COPPERSTRING EIS

Attachment F - Vegetation Clearing Works plans

Dajarra Road to Mount Isa

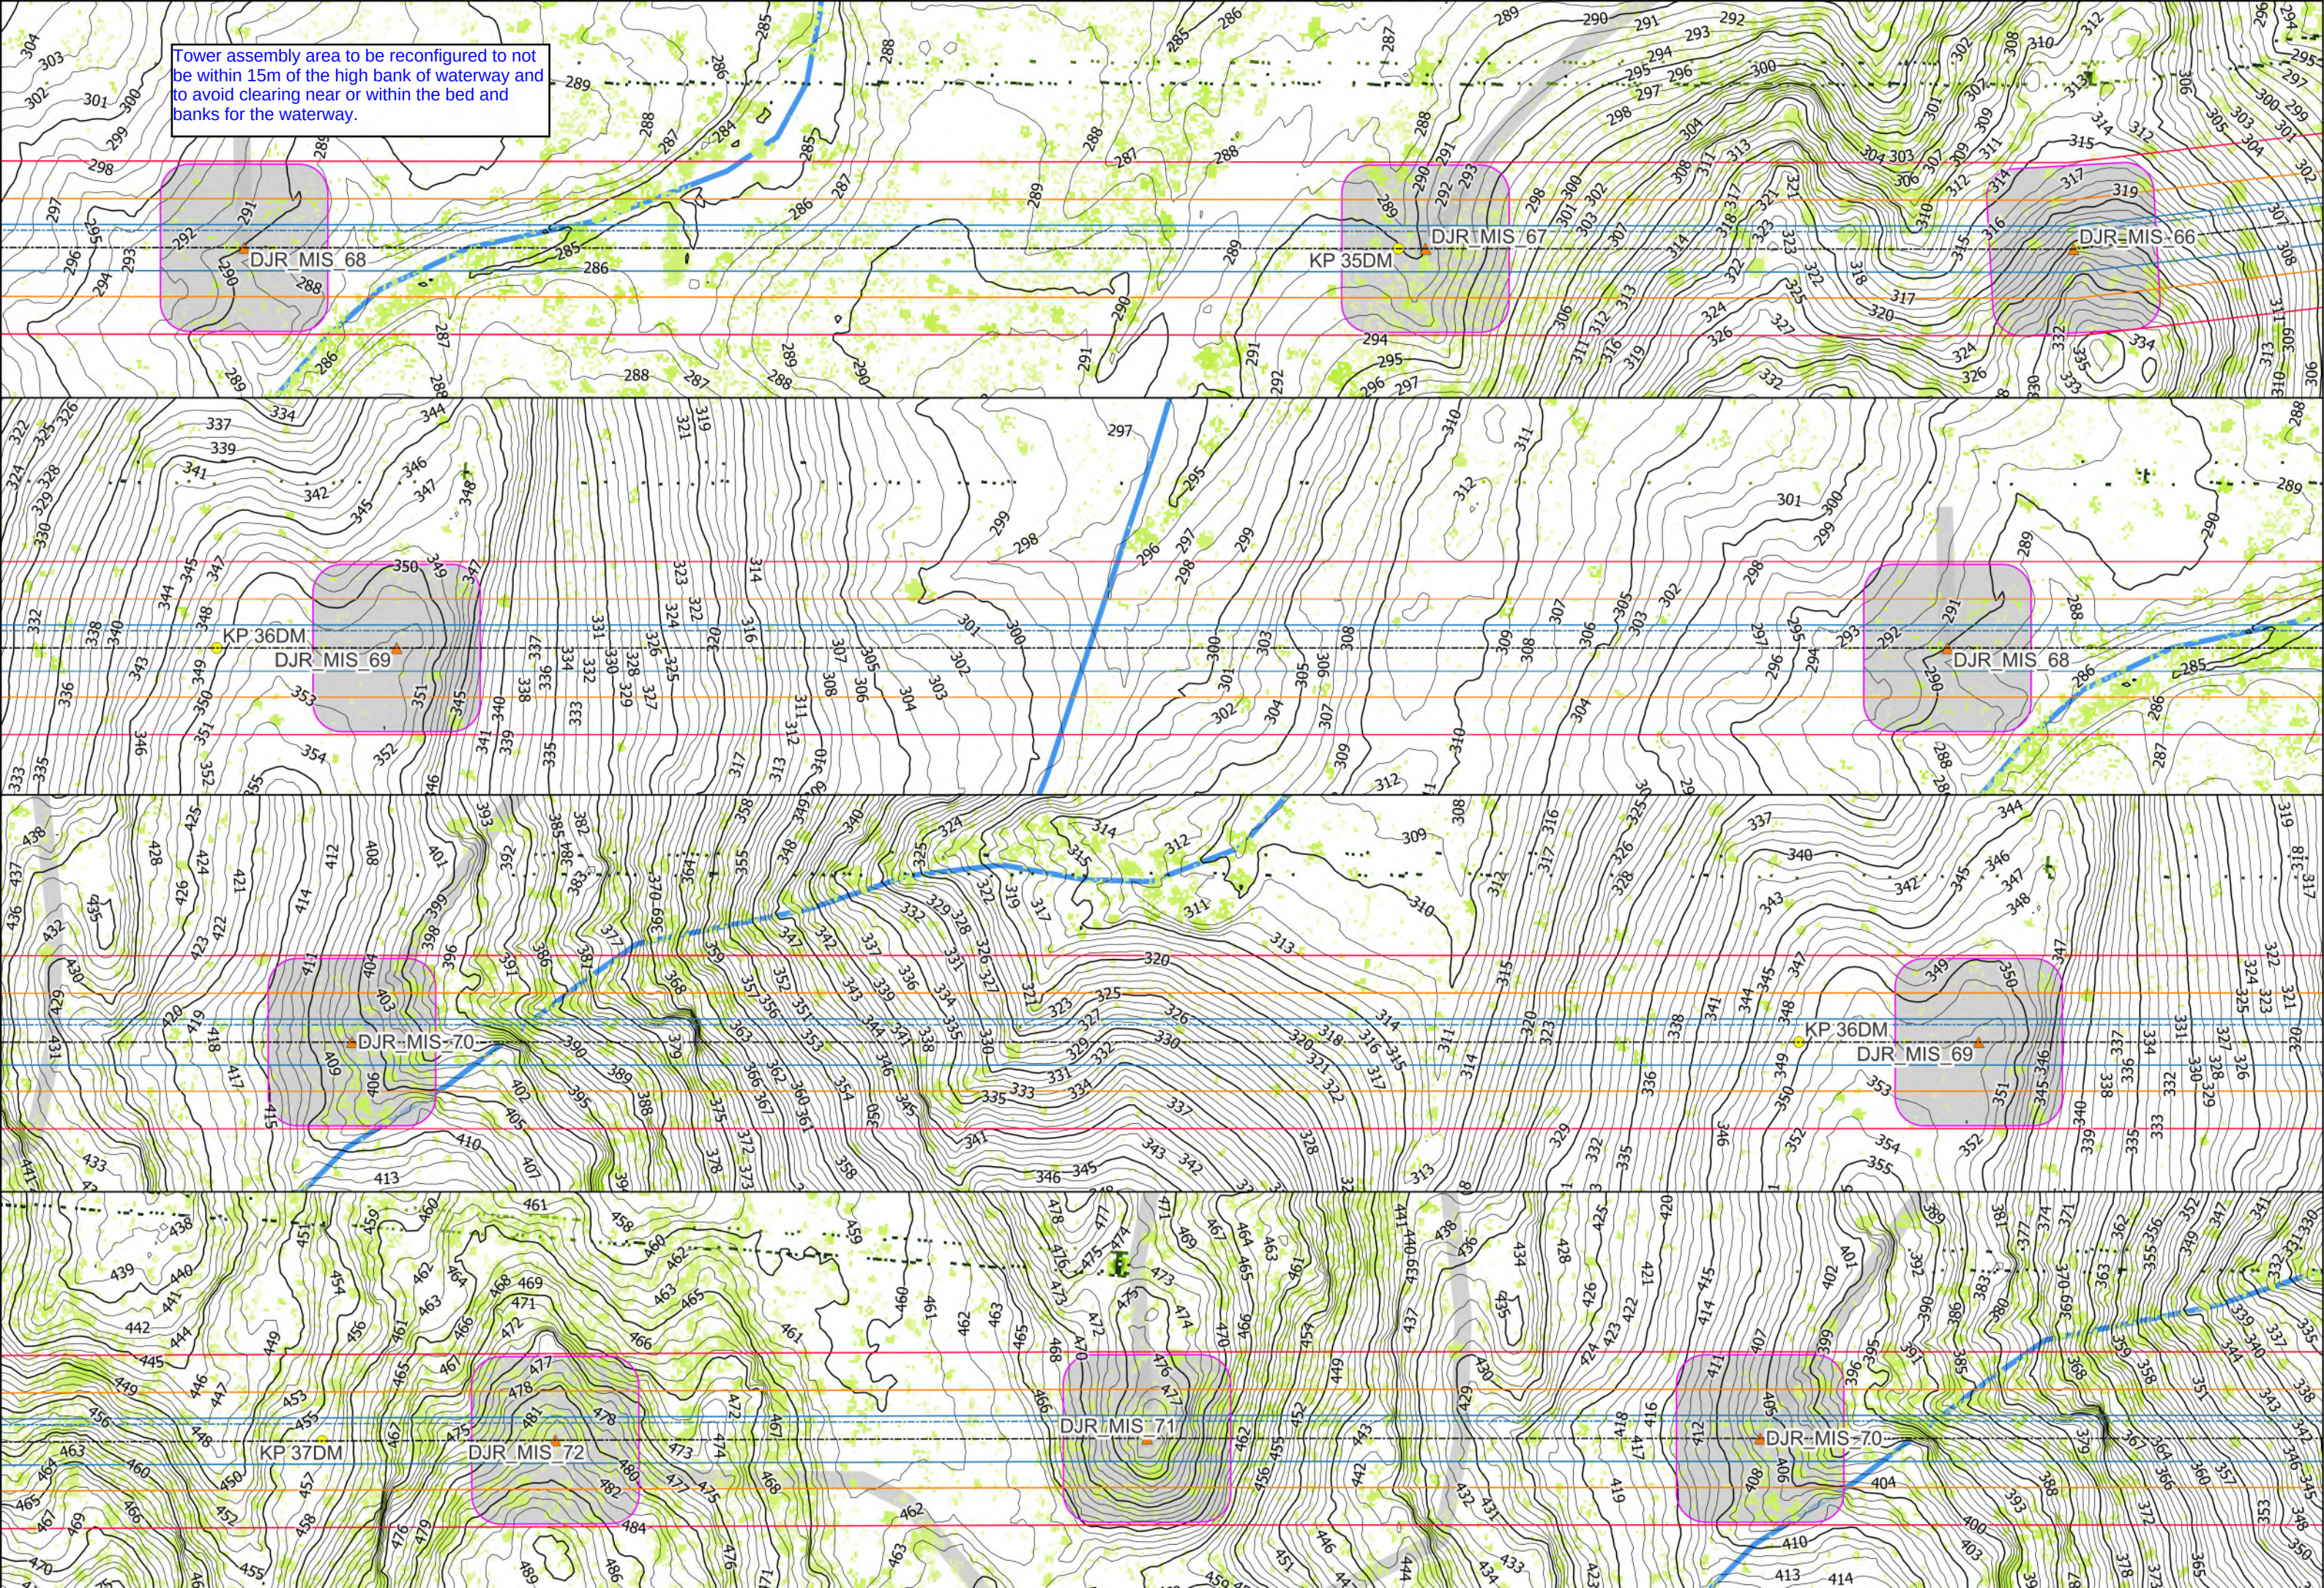
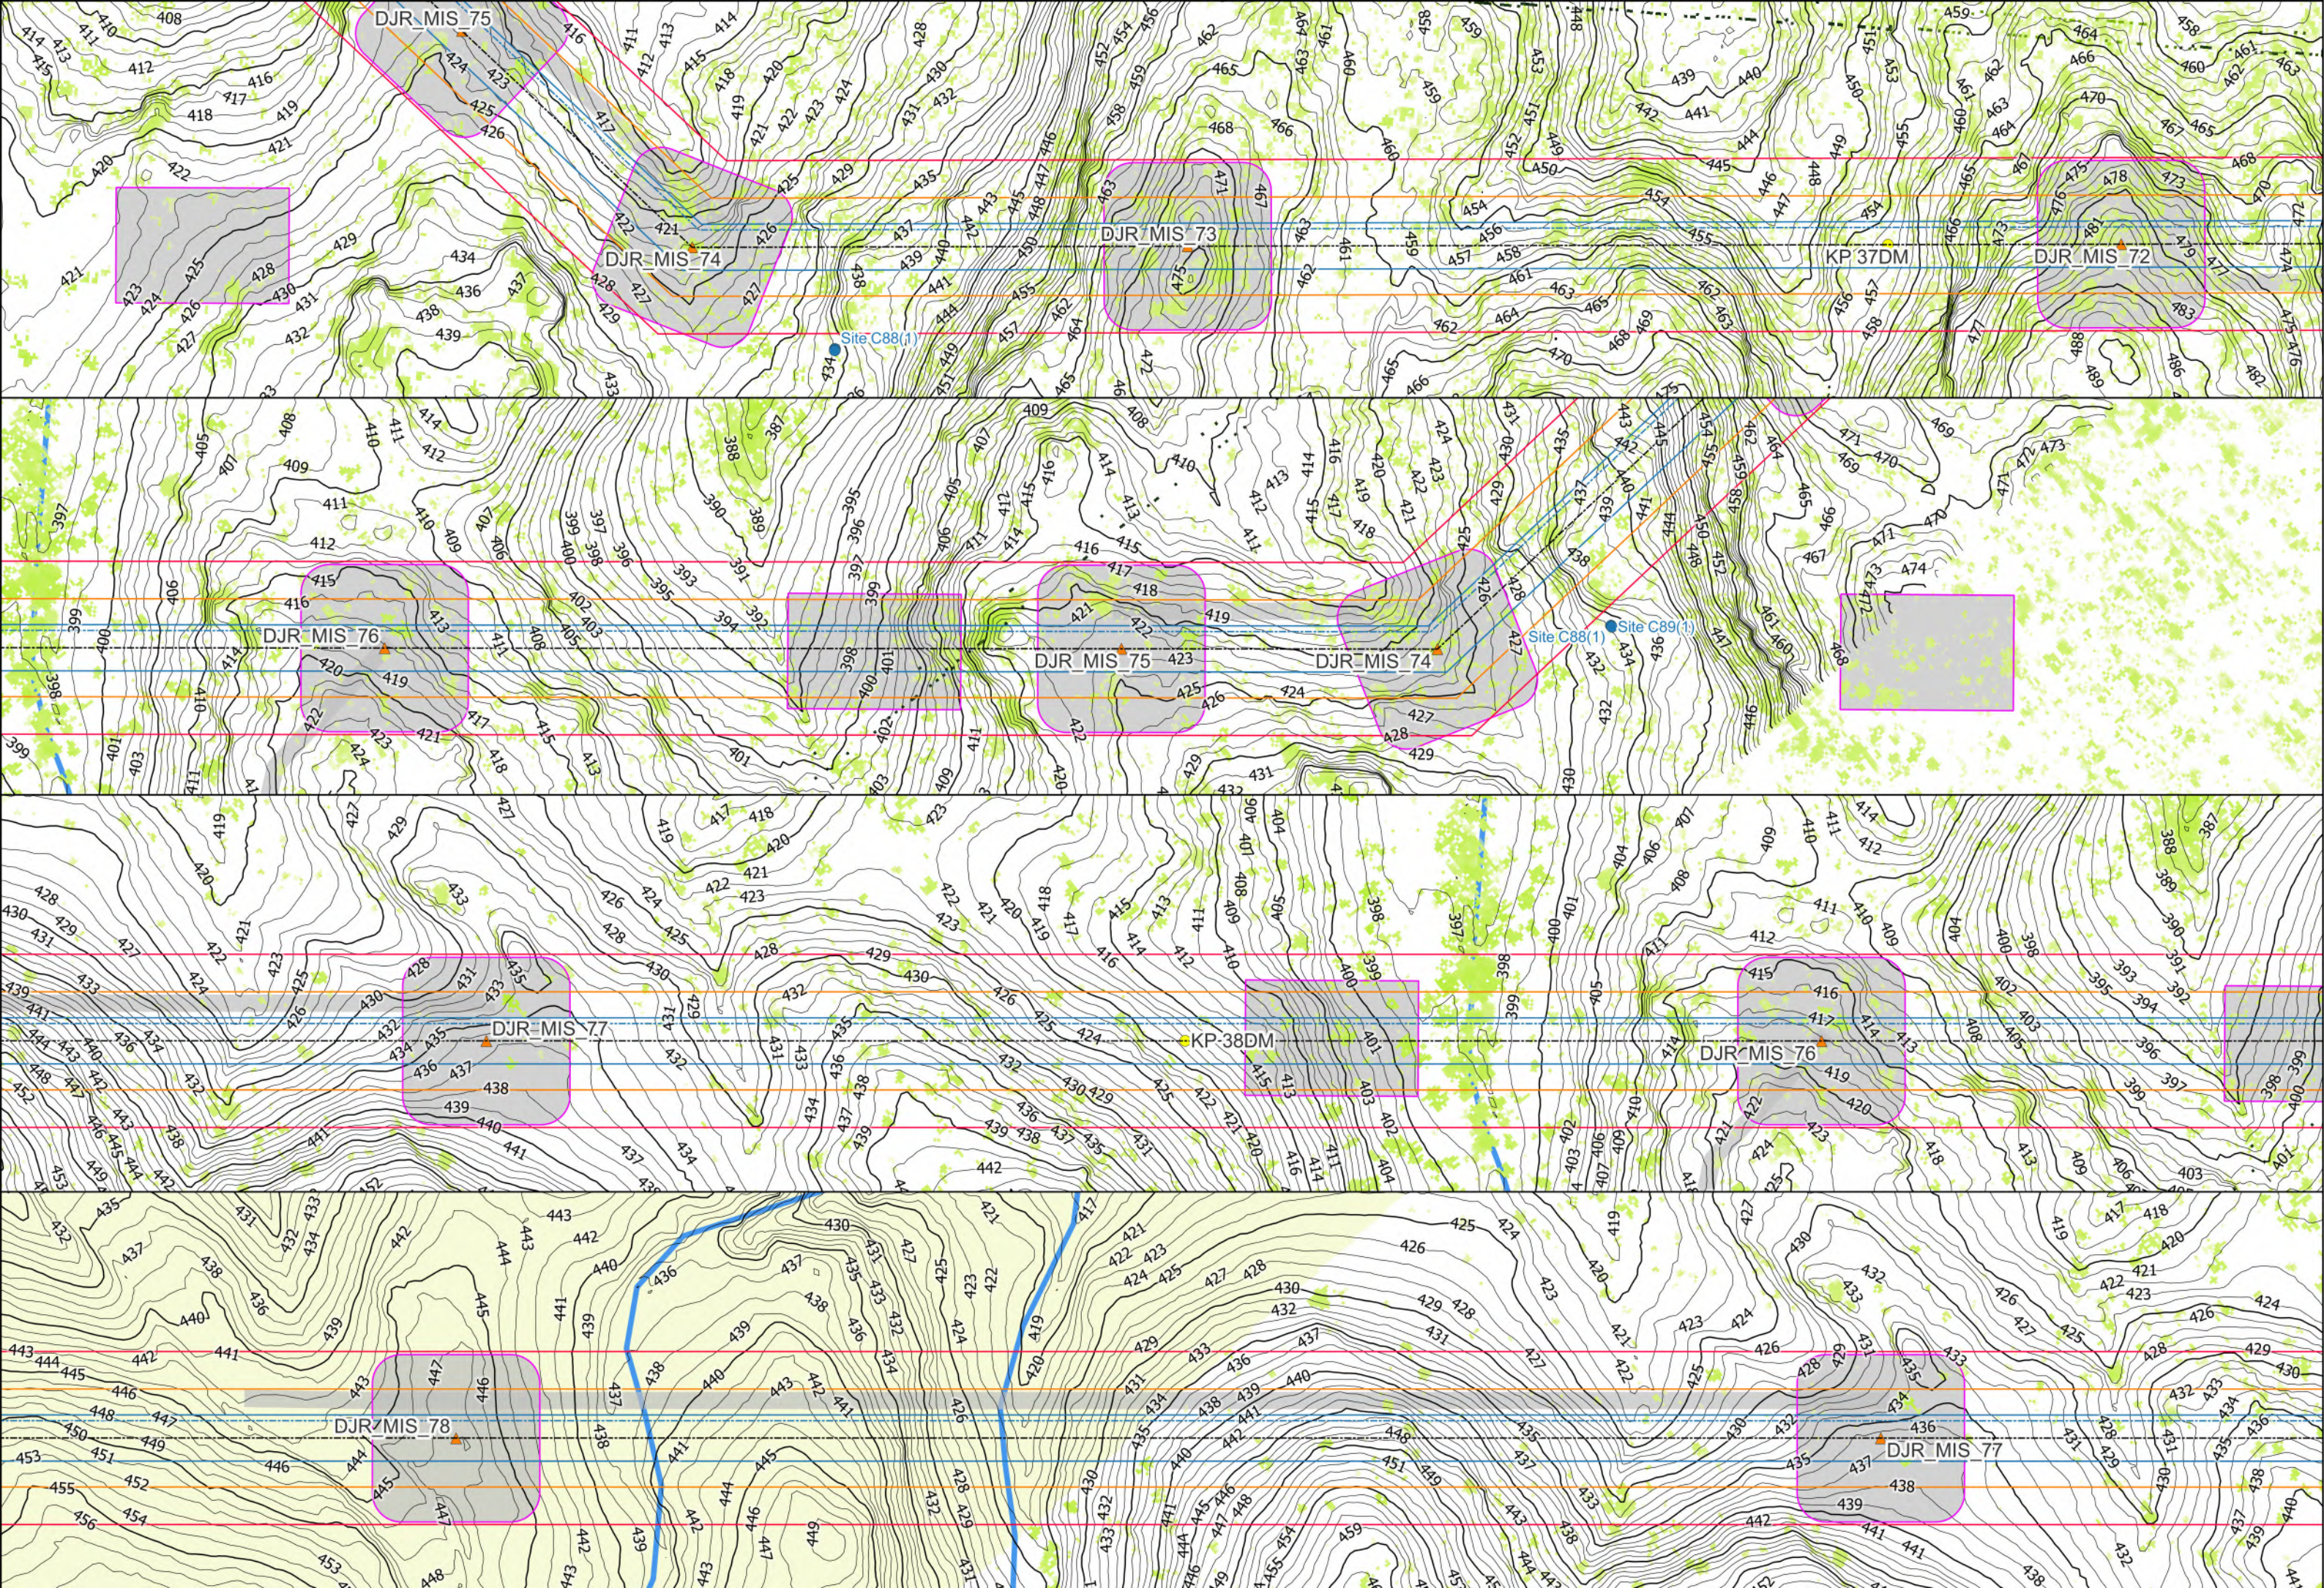
Tower assembly area to be reconfigured to not be within 15m of the high bank of waterway and to avoid clearing near or within the bed and banks for the waterway.
